SUBJECT: **Modification to improve crunch problems with 800 MHz MPA's**

Modification required for MPA retry problems due to aging radios. This applies to 800 MHz radios which have begun to exhibit a retry problem. There is no need to make these modifications to radios which do not exhibit this problem.

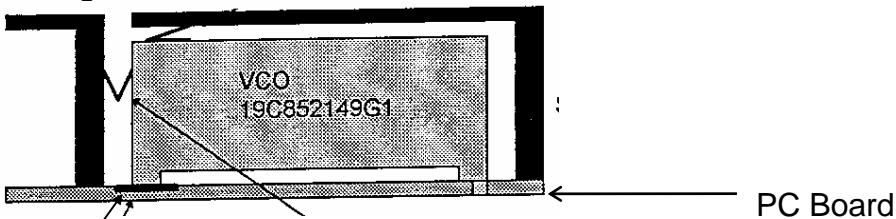
10) Once the board has been secured to the eggcrate look at the edges to ensure no gaps are present between the board top and eggcrate edge.

11) The copper grounding springs need to be put back in place. Push all 3 shields in around the VCO and verify that they drop below the edge of the eggcrate top surface. Also these shields should make contact between the sides of the VCO and the eggcrate.

Copper ground spring Part Number 19B235901P1.

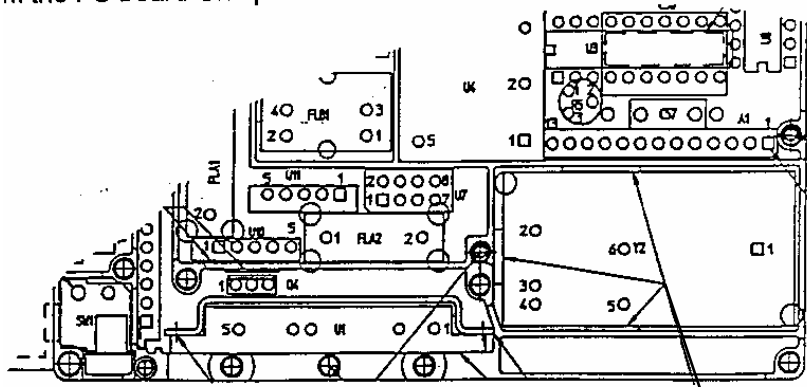
8) An additional copper grounding spring must be soldered on the top of the VCO. See diagram for placement.

This spring is soldered to the upper edge of the VCO as shown. Do not use excessive solder. Spring must still compress after being soldered.

The two unsolder corners of the VCO must be insulated from the PC board Gnd plane.

↑
Placement of 3 copper grounding springs.
